PARKWAY PLACE SUBDIVISION

FIRST ADDITION

APPLICATION NUMBER 11 DATE October 20, 2016

DETAIL SITE PLAN

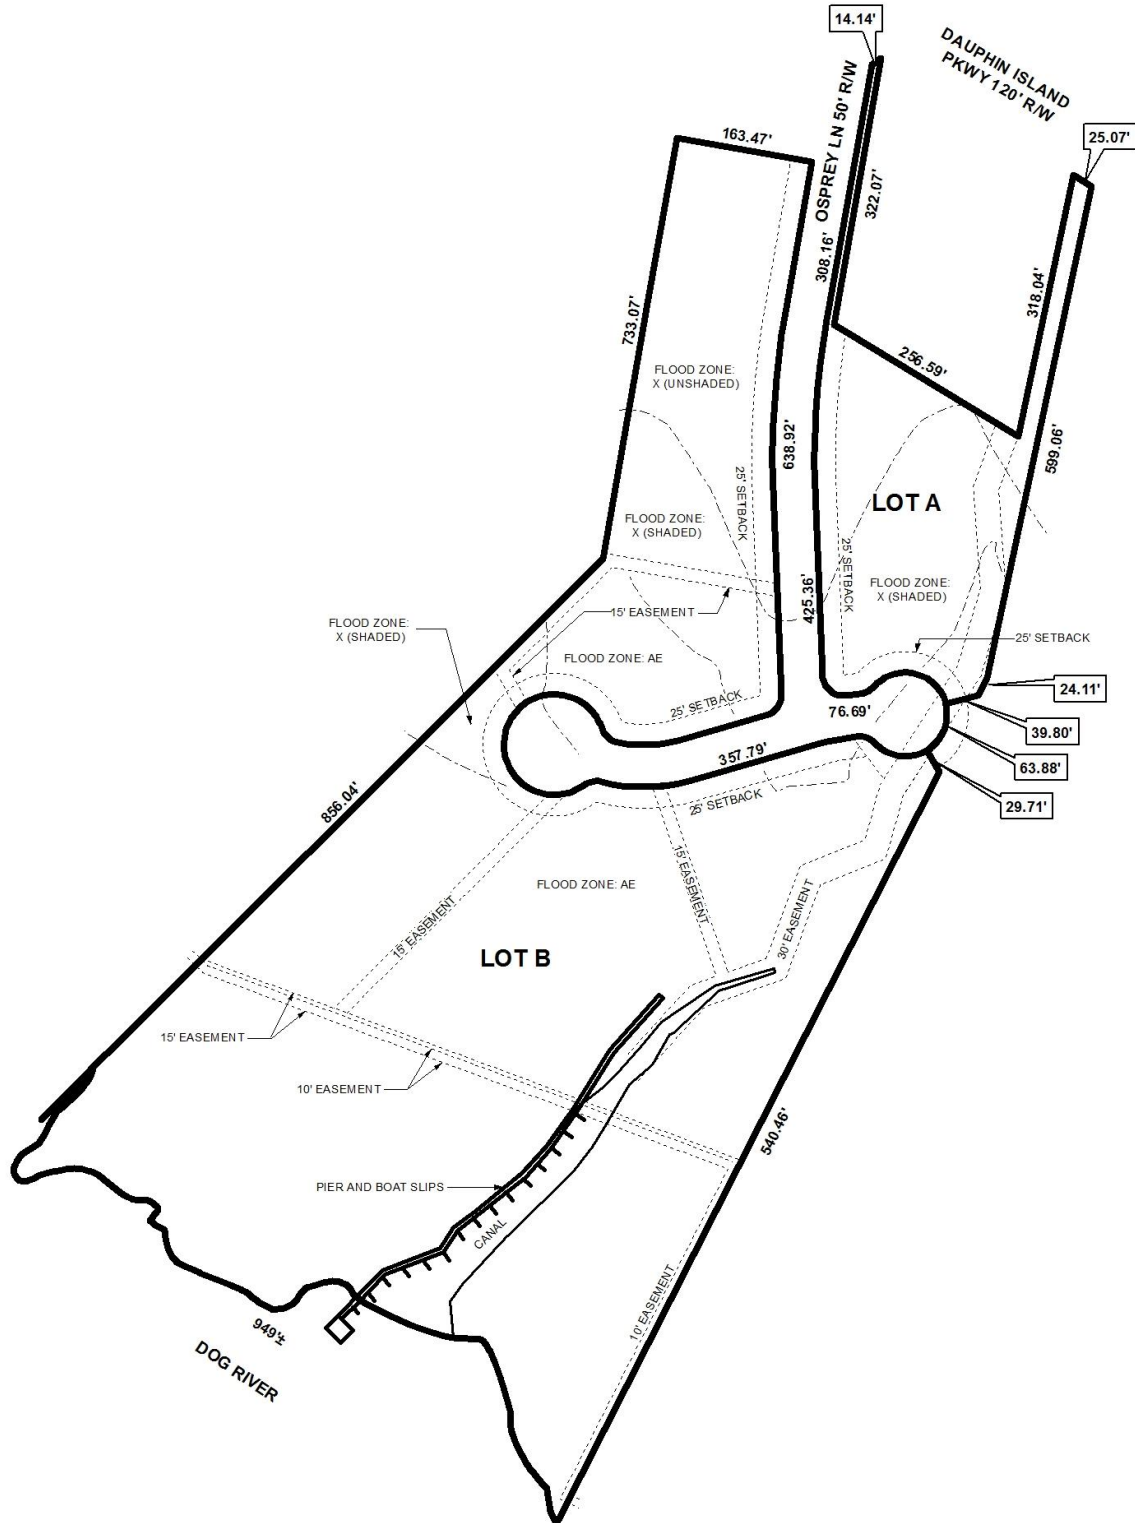
Lot A should be limited to two curb-cuts, while Lot B should be limited to three curb-cuts with the size, design and location to be approved by Traffic Engineering and in conformance with AASHTO standards. The proposed Lot A has frontage on the existing minor streets and Dauphin Island Parkway. Given Lot A's limited frontage on Dauphin Island Parkway, it should be denied direct access to Dauphin Island Parkway.

The 25' minimum building setback lines are depicted along Lot B. However, 25' minimum building setback line is not depicted in all of the required areas for the proposed Lot A. Section V.D.2. of the Subdivision Regulations requires that all lots be a minimum 60' wide at the minimum building setback line. Therefore, the applicant should revise the plat accordingly to depict the minimum building setback line where the lot reaches 60 in width, from all street frontages.

The proposed lots are unusually shaped, include flag-lot characteristics, and appear to exceed the recommended width to depth ratio of the Subdivision Regulations; however due to the close proximity to Dog River and the potential presence of wetlands in the area, a waiver of Sections V.D.1. and V.D.3. of the Subdivision Regulations may be appropriate.

As illustrated on the plat, drainage and sewer easements exist on the site. If approved, a note should be placed on the final plat stating that no structures are allowed within these easements.

- 4) Retention of the lot sizes in square feet and acres;
- 5) Retention of the 25' minimum building setback line along Lot B;
- 6) Revision of the plat to depict the minimum building setback line for Lot A to where the lot is 60' in width for all street frontages.

- 7) Placement of a note on the plat stating that Lot A is denied access to Dauphin Island Parkway;
- 8) Placement of a note on the plat stating Lot A should be limited to two curb-cuts, while Lot B should be limited to three curb-cuts with the size, design and location to be approved by Traffic Engineering and in conformance with AASHTO standards;

- 9) Placement of a note on the Final Plat stating that no structures are allowed within any easement;
- 10) Compliance with Engineering comments: *"FINAL PLAT COMMENTS (should be addressed prior to submitting the FINAL PLAT for acceptance and signature by the City Engineer): A. Provide all of the required information on the SUBDIVISION PLAT (i.e. signature blocks, signatures, certification statements, written legal description, required notes, legend, scale, bearings and distances) that is required by the current Alabama State Board of Licensure for Professional Engineers and Land Surveyors. B. Show and label the existing lots. C. Add legible street names to the vicinity map. D. Provide legible items in the legend. E. Show and label the MFFE (Minimum Finished Floor Elevation) on each lot that contains an AE, V, or X (shaded) flood zone designation. F. Provide and label the monument set or found at each subdivision corner. G. Add a signature block for the Owner, Notary Public, Planning Commission, Traffic Engineer, and City Engineer. H. Provide the Surveyor's Certificate and Signature. I. Provide the Surveyor's, Owner's (notarized), Planning Commission, and Traffic Engineering signatures. J. Add a note to the SUBDIVISION PLAT stating that a Land Disturbance permit will be required for any land disturbing activity in accordance with Mobile City Code, Chapter 17, Storm Water Management and Flood Control); the City of Mobile, Alabama Flood Plain Management Plan (1984); and, the Rules For Erosion and Sedimentation Control and Storm Water Runoff Control. K. Add a note to the Plat stating that the approval of all applicable federal, state, and local agencies (including all storm water runoff, wetland and floodplain requirements) will be required prior to the issuance of a Land Disturbance permit. L. Add a note that sidewalk is required to be constructed, and/or repaired, along the frontage of each lot, or parcel, at time of new development or construction, unless a sidewalk waiver is approved. M. Provide a copy of the FINAL PLAT to the Engineering Dept. for FINAL PLAT review prior to obtaining any signatures. N. After*
